# MEHDIPOUR/SIGNAL HILL, LLC

PLN240077

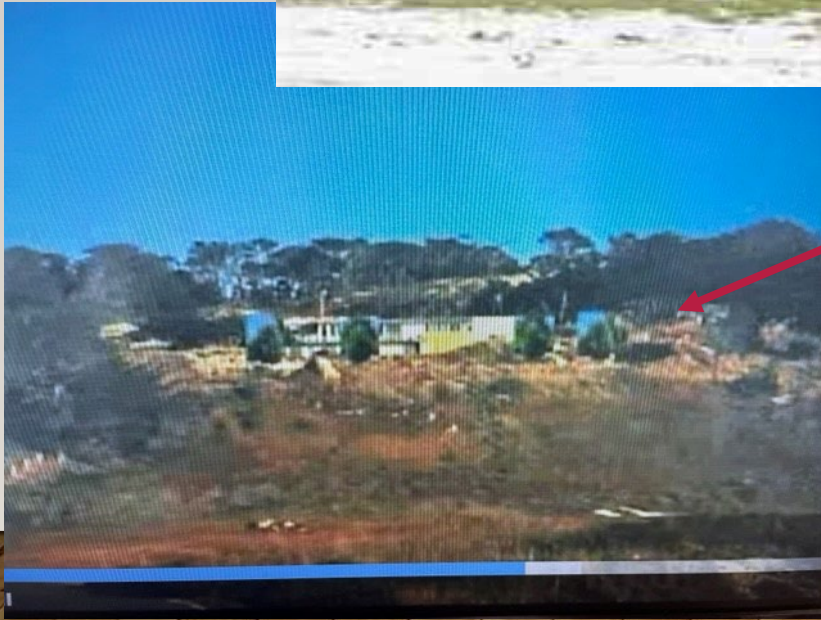
Red Line --- Connell House

Black Line --- Proposed House

Area Outside Footprint  
1,300 SF +/-

- 
- stay within the footprint of the Connell House and reduce the height of the dwelling from the original proposal (Staff report, page 2)
  - stipulation that the new home construction remain in the footprint of the Connell House as it was. (Attachment A, page 3)

- The Board directed the applicant to return with a design that is within the footprint of the Connell House. The proposed structure does not (Attachment A, page 5)

# CONDITION 10- STAFF RECOMMENDATION TO MINIMIZE CONSERVATION EASEMENT

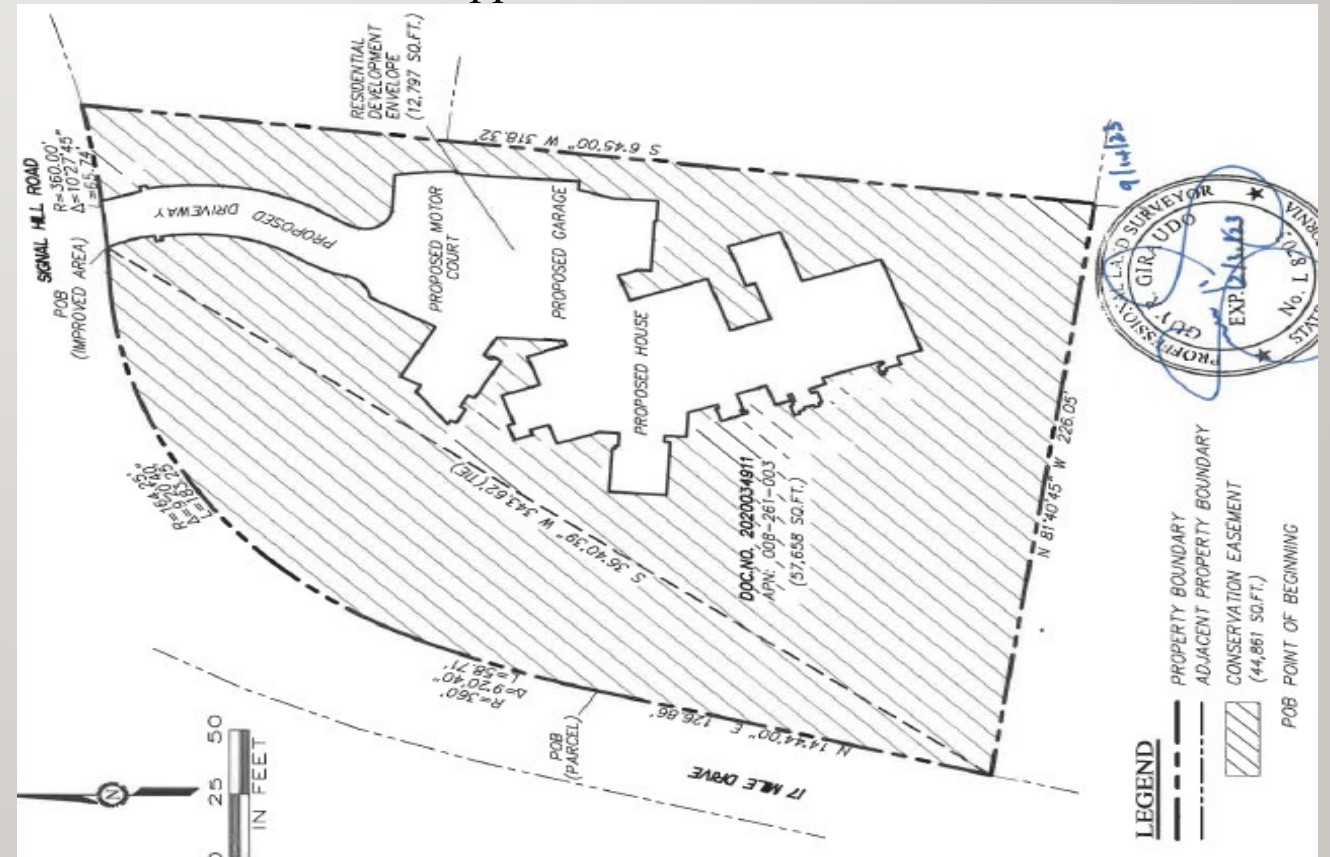
- A Reduced Conservation and Scenic Easement and restoration area is inconsistent with LCP and Coastal Act
- Coastal Staff found the previous Mehdipour proposal inconsistent (January 2023) “The expansion of residential development, a non-resource dependent use, such as is proposed here, is not permissible under the LCP at this time”
- Similar decision on the 5B project appealed by the Coastal Commission; 5B application amended to be consistent with LCP and Coastal Act; appeal withdrawn
- Final 5B Easement encompasses entire shaded area (accepted by Board July 2024)
